**BID ADDENDUM NO. 2**

PROJECT NAME: PORT CHESTER FLOOD REPAIRS AND RELATED WORK  
JOHN F. KENNEDY ELEMENTARY SCHOOL

F&D PROJECT #: 21444.01

DATE: October 28, 2021

PROJECT: JOHN F. KENNEDY ELEMENTARY SCHOOL  
DRAWING TITLE: PARTIAL GROUND FLOOR PLANS & INTERIOR ELEVATIONS  
DRAWING NO.: A150

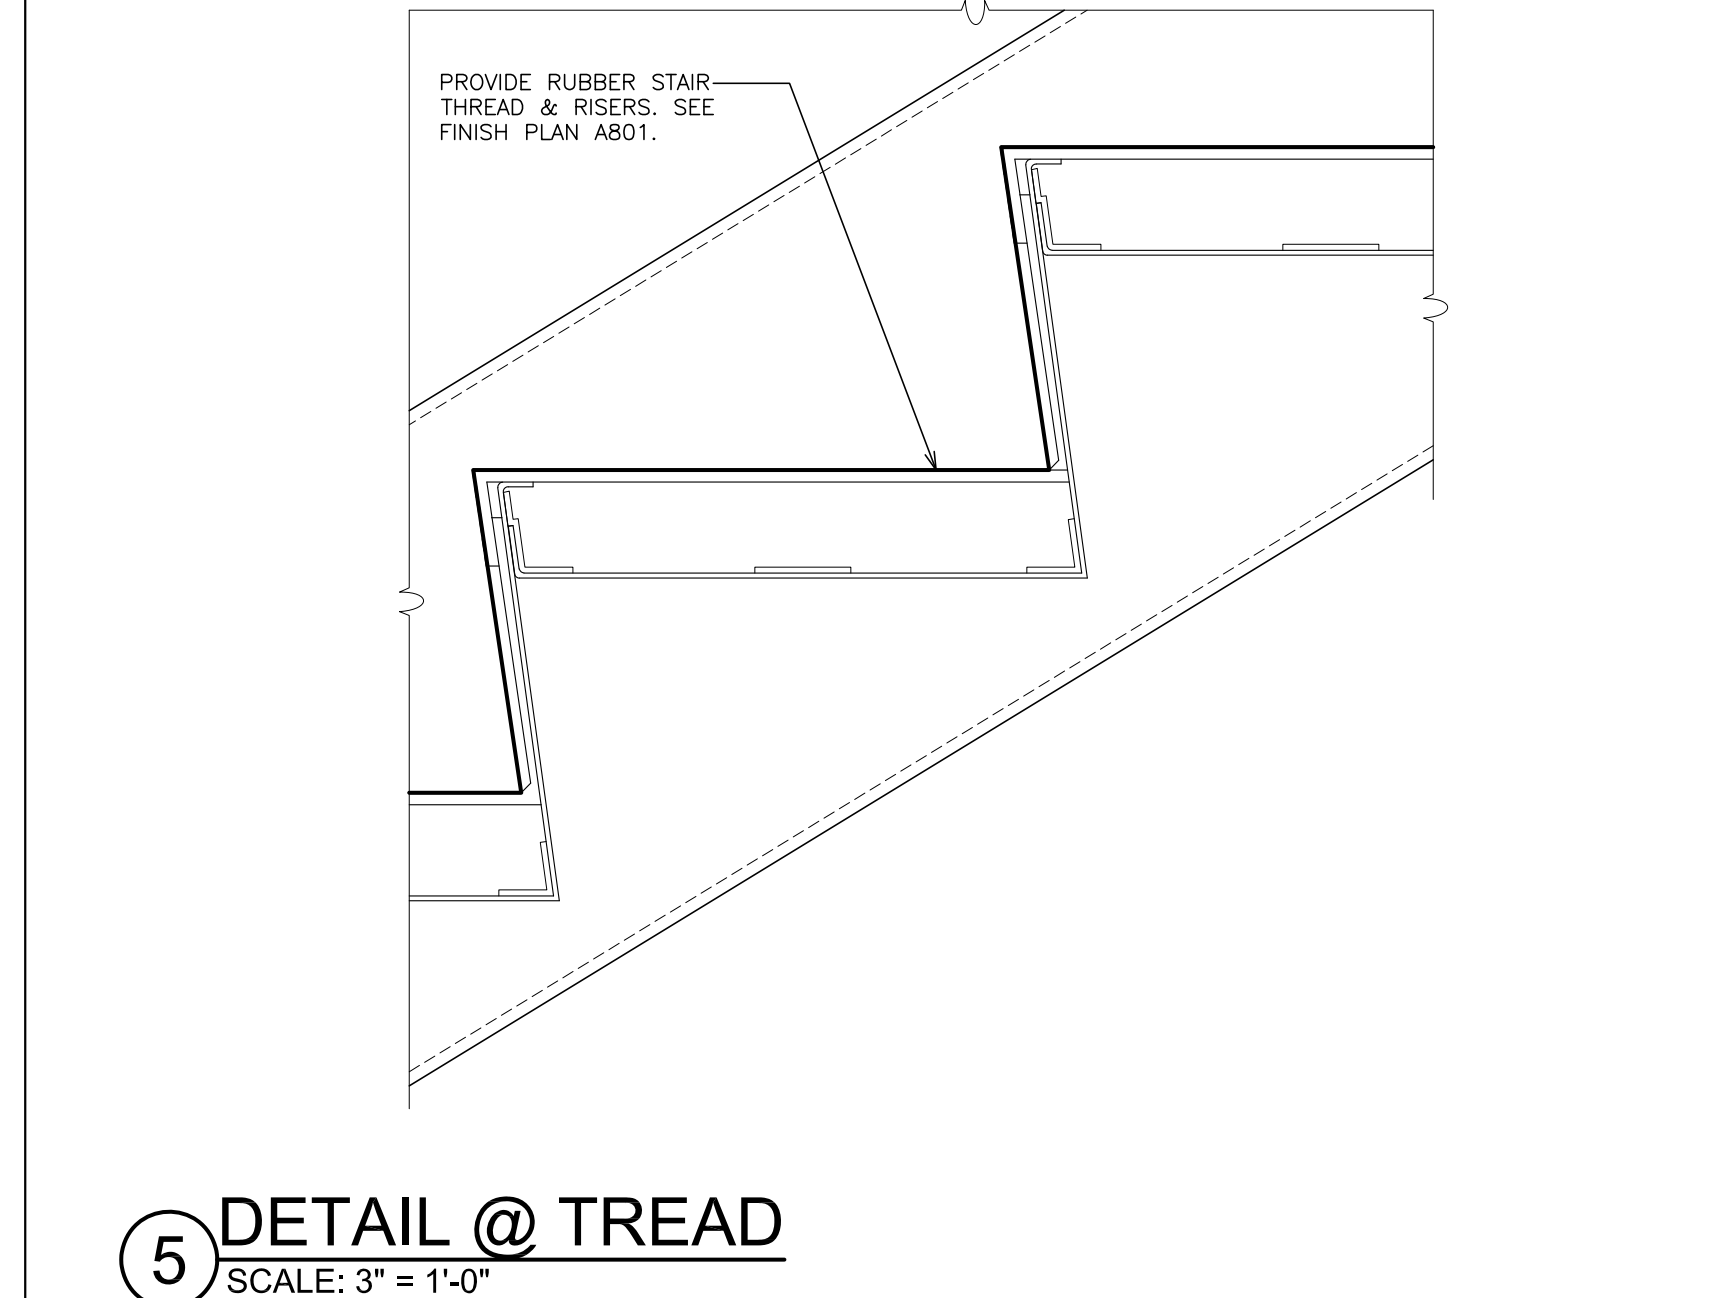
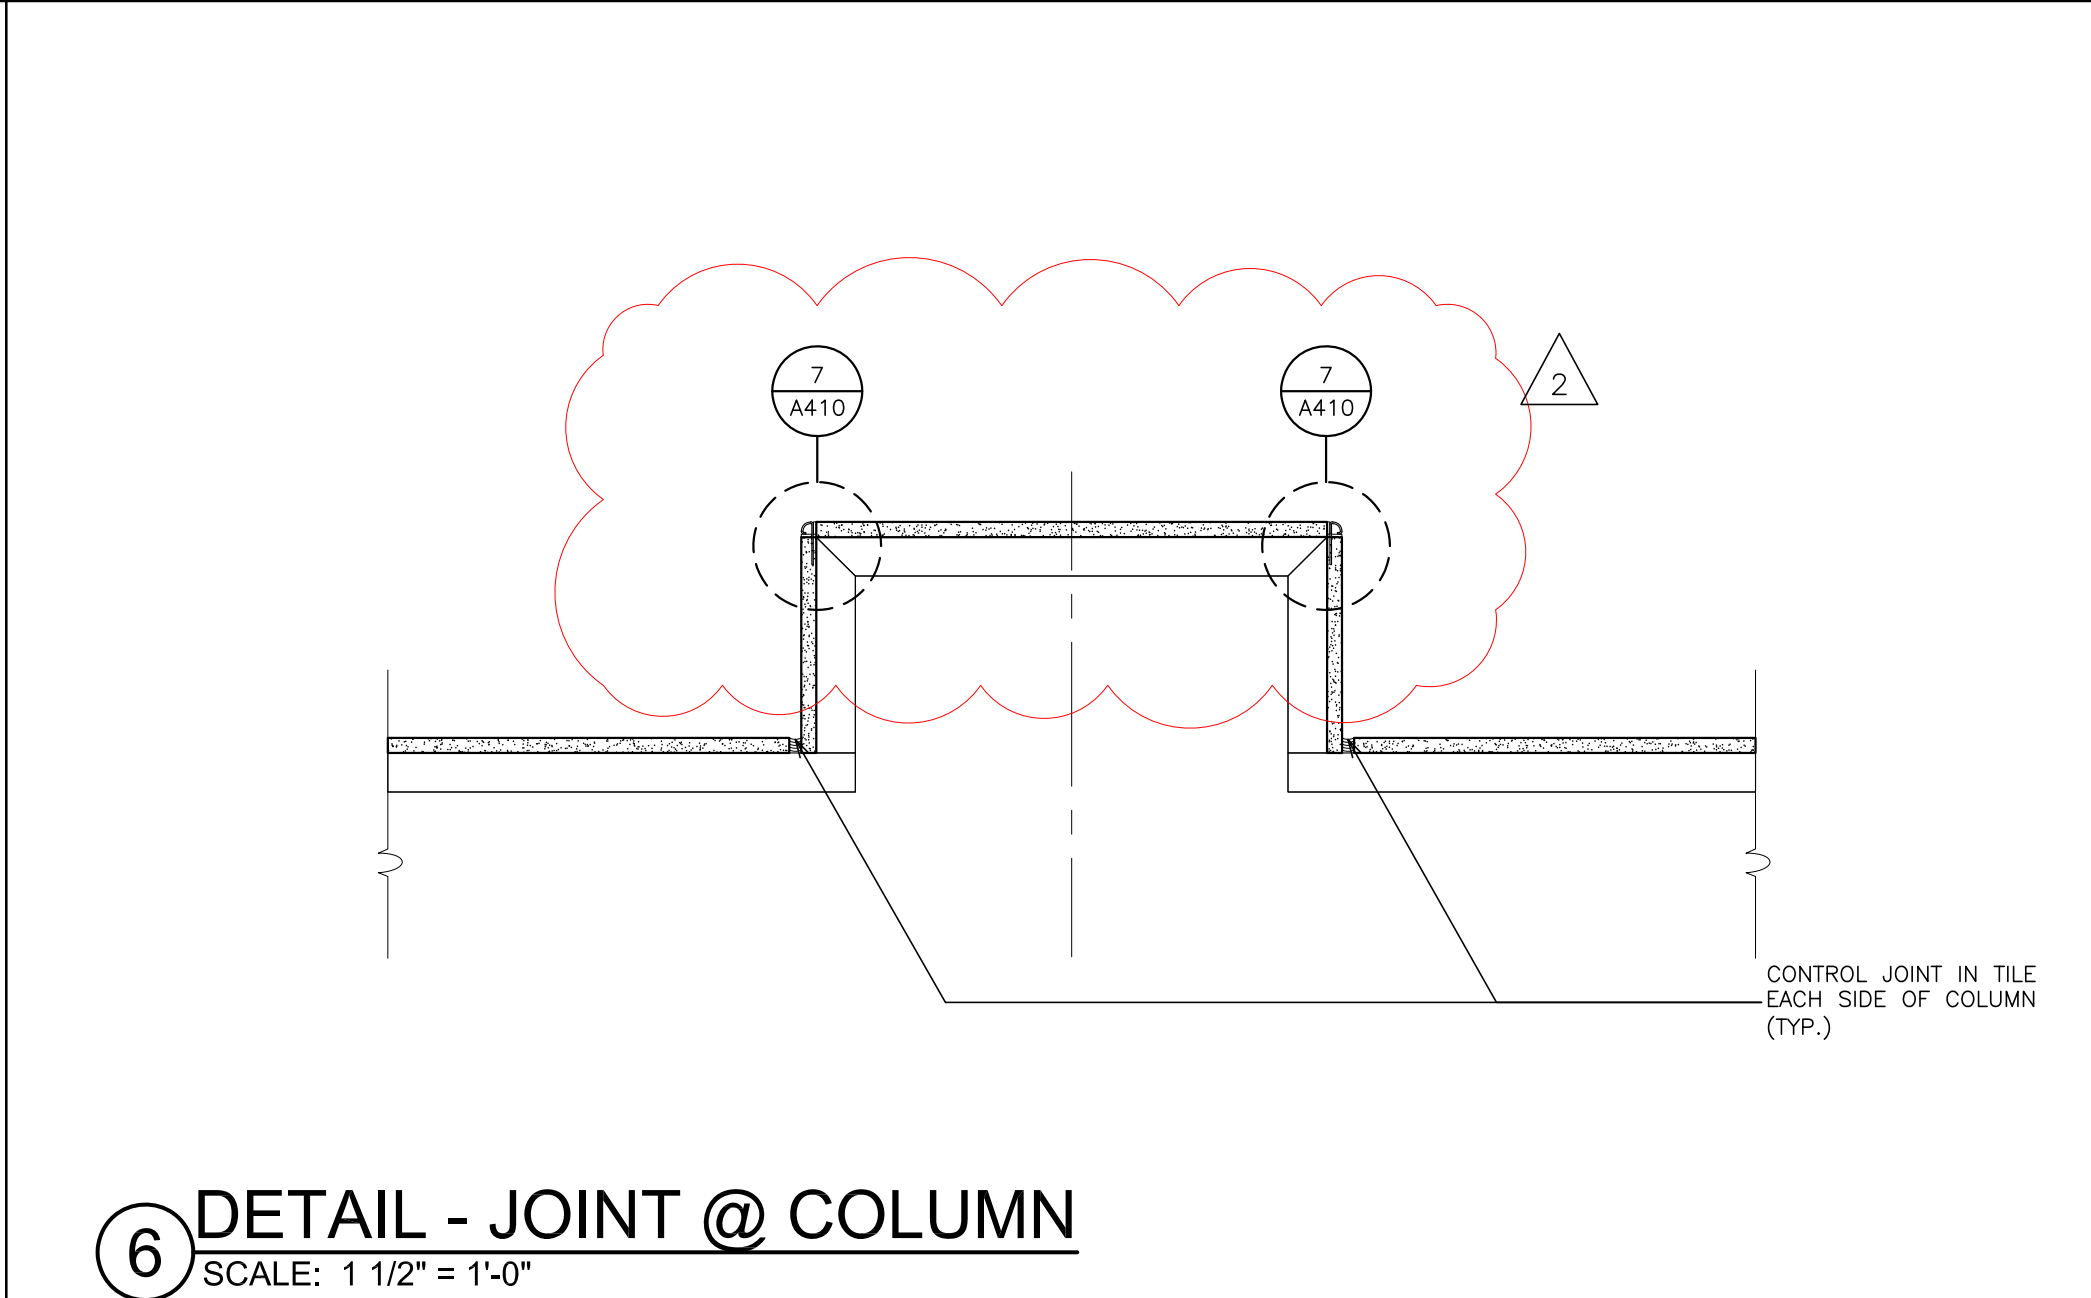
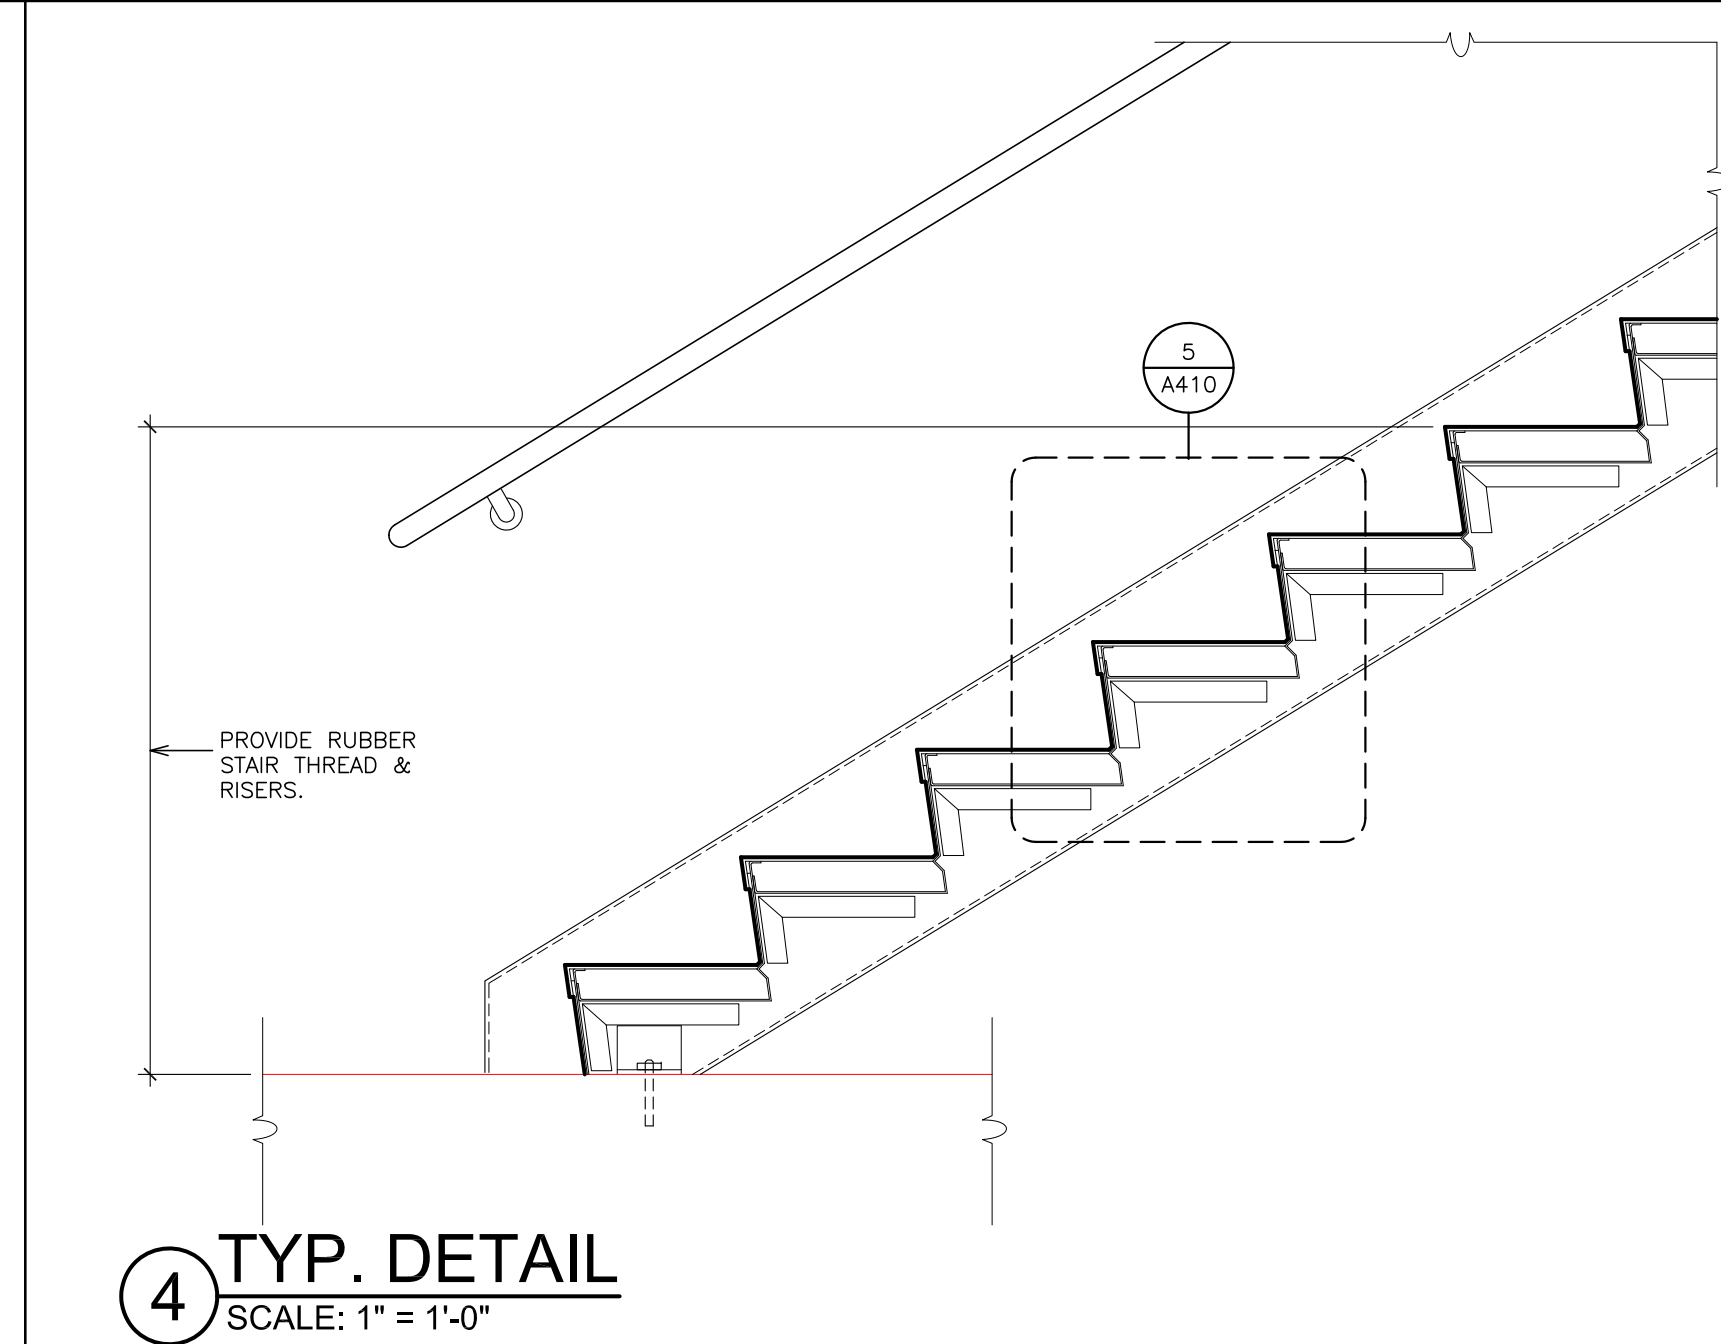
Revised drawing.
